NUMBER
DEP15897

LINE	QUANTITY	UOP	CAT NO	ITEM NUMBER	UNIT PRICE	AMOUNT
				ADDENDUM NO.3		
				ADDENDUM FOR THE LAND RECLAMATION PROJECT NEAR CALVIN, WV. ISSUED PER THE ATTACHED DOCUMENTATION TO PUBLISH THE FOLLOWING INFORMATION.		
				1. ADDITIONAL CLARIFYING STATEMENTS OF PROJECT, PER THE ATTACHED DOCUMENTATION.		
				END OF ADDENDUM NO. 3		
0001		JB		962-73		
				RECLAMATION: RESTORATION OF LAND & OTHER PROPERTIES		
				***** THIS IS THE END OF RFQ DEP15897 ***** TOTAL:

Addendum Number: 03

DEP15897**Level Land Construction Company (S-3007-89, S-3027-90, S-3026-88)****Additional Clarifying Statements****Addendum No. 3****CLARIFICATIONS**

SPECIAL RECLAMATION	
LEVEL LAND CONSTRUCTION CO. INC. PERMIT NO'S S-3007-89, S-3027-90, S-3026-88 HAULROAD/ACCESS ROAD CLARIFICATION MAP	
SCALE Not To Scale	DRAWN BY:
DATE:	PROJECT NO: Addendum No. 3

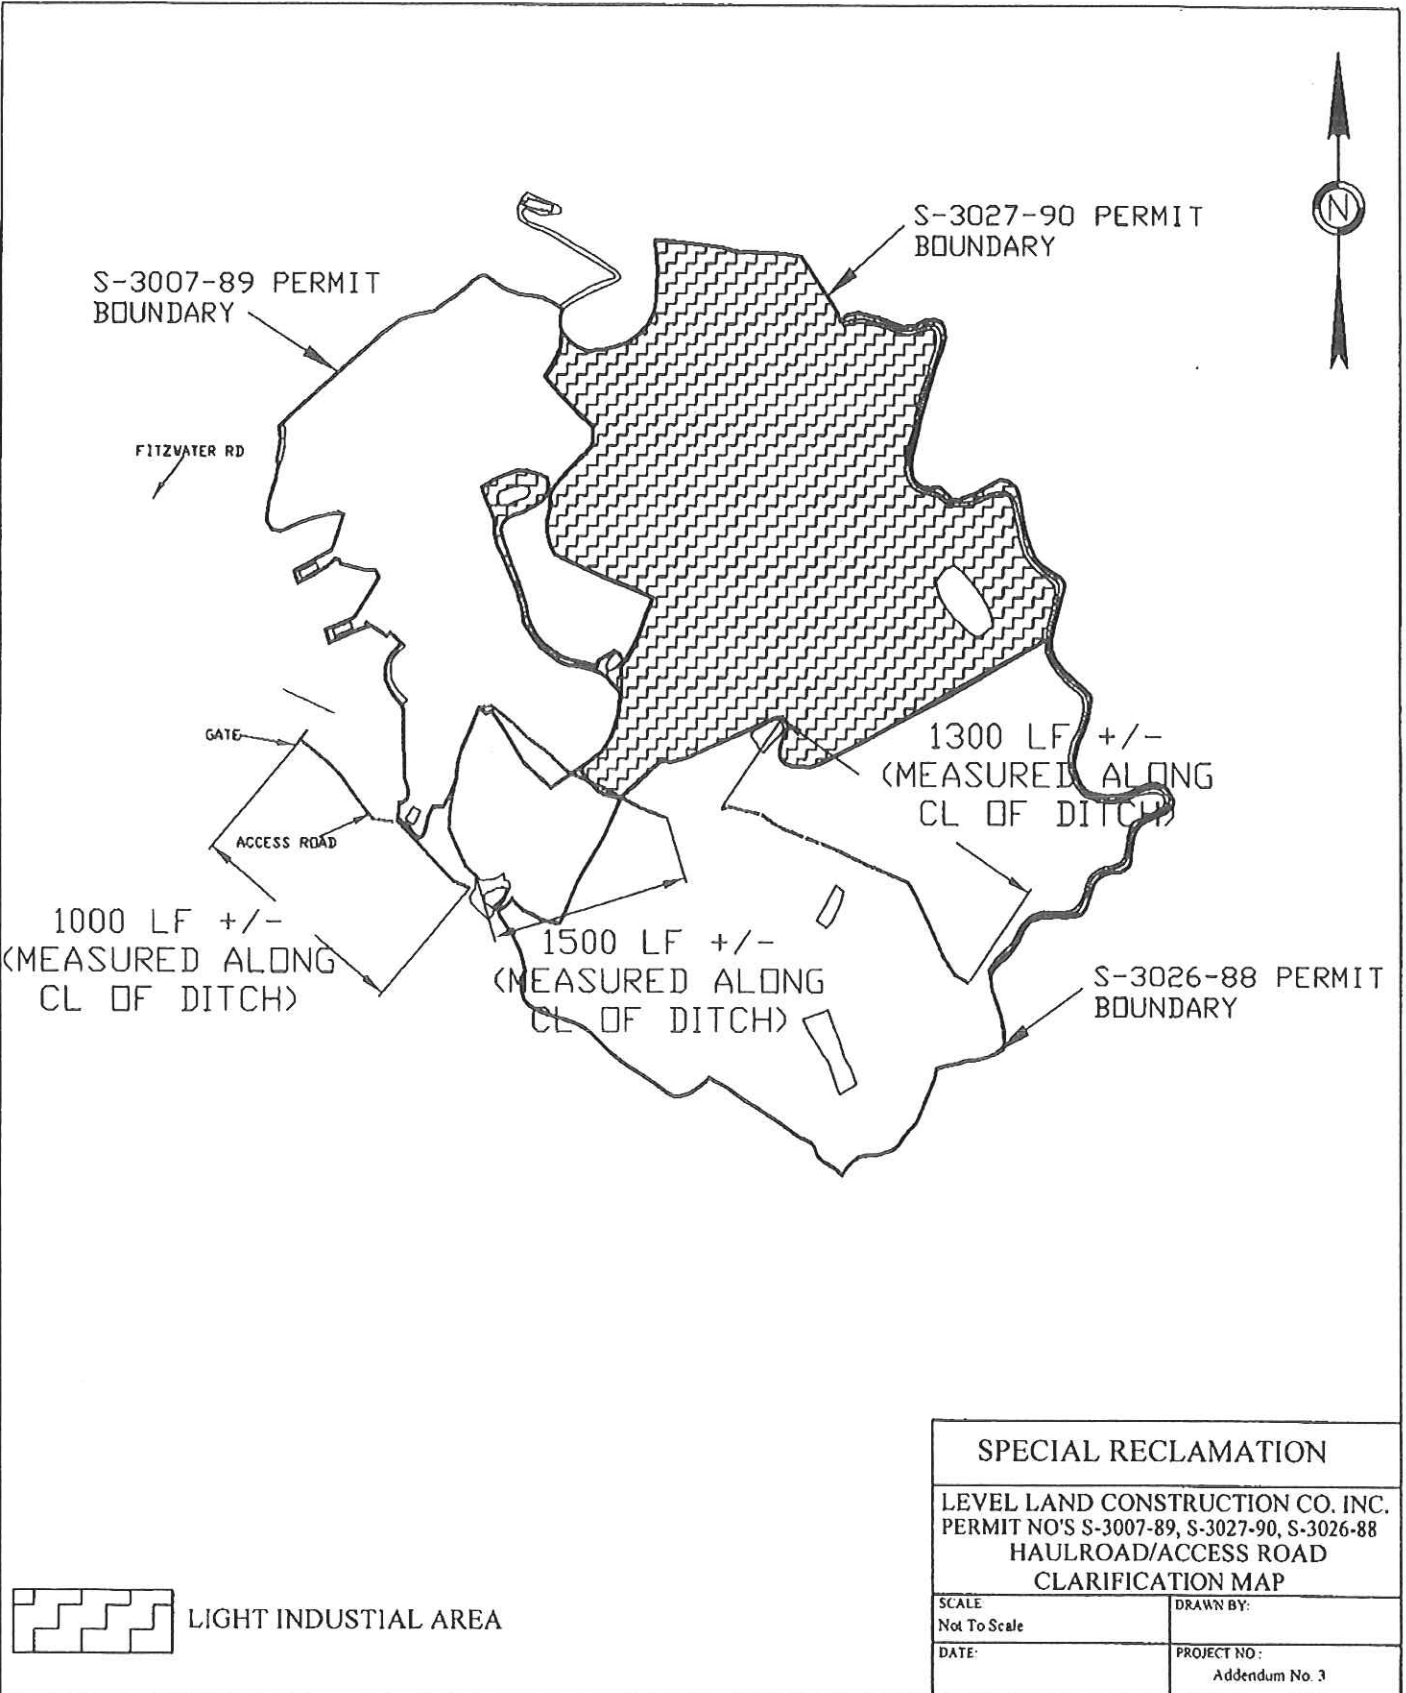
Note: This ditch is approximately one thousand (1,000) linear feet in length. See attached Haulroad/Access Road Clarification Map for approximate location.

Note: This ditch is approximately fifteen hundred (1,500) linear feet in length. See attached Haulroad/Access Road Clarification Map for approximate location.

Note: This ditch is approximately thirteen hundred (1,300) linear feet in length. See attached Haulroad/Access Road Clarification Map for approximate location.

SPECIAL RECLAMATION	
LEVEL LAND CONSTRUCTION CO. INC. PERMIT NO'S S-3007-89, S-3027-90, S-3026-88 TYPICAL CROSS SECTION OF CONSTRUCTED DITCH LINE	
SCALE: Not To Scale	DRAWN BY:
DATE:	PROJECT NO: Addendum No. 3

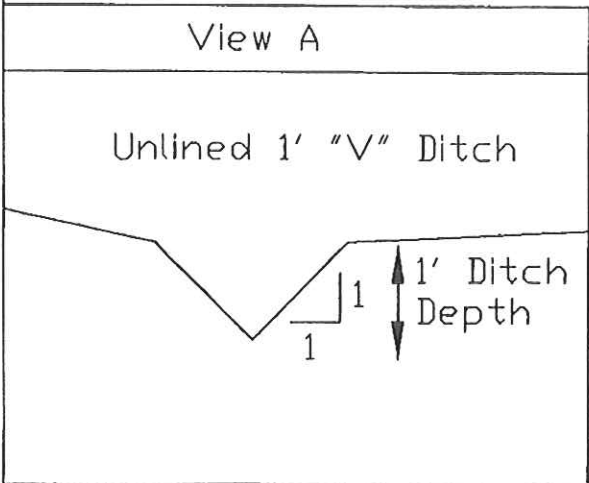
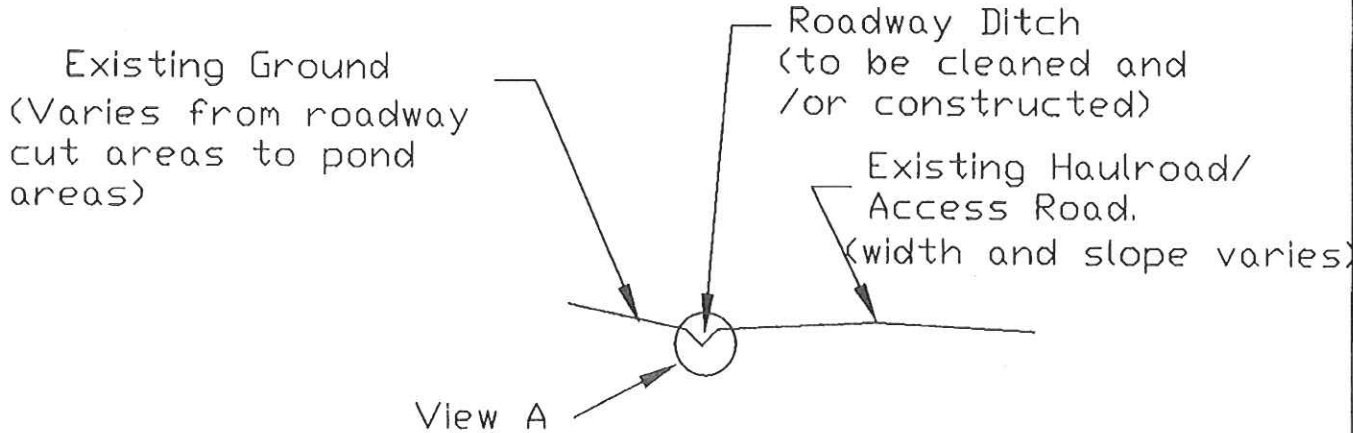
- The Haulroad/Access Road bid item shall include the construction of a one (1) foot unlined "V" ditch from the gate (cable gate), coming off of the county road, to the first left turn to go up the hill. See attached typical cross section of constructed ditch line. In sections of the above mentioned haulroad/access road where existing ditch line is larger than the required one (1) foot "V" ditch contractor shall remove any debris and alluvial material from ditch line to ensure free draining of ditch line. Contractor shall also clean entire length of each culvert located within this area if deemed necessary by WVDEP agent onsite by means that will not damage culverts nor cause sedimentation from leaving permit area. All the above mentioned work will be incidental to and included in the Haulroad/Access Road bid item. The above mentioned work
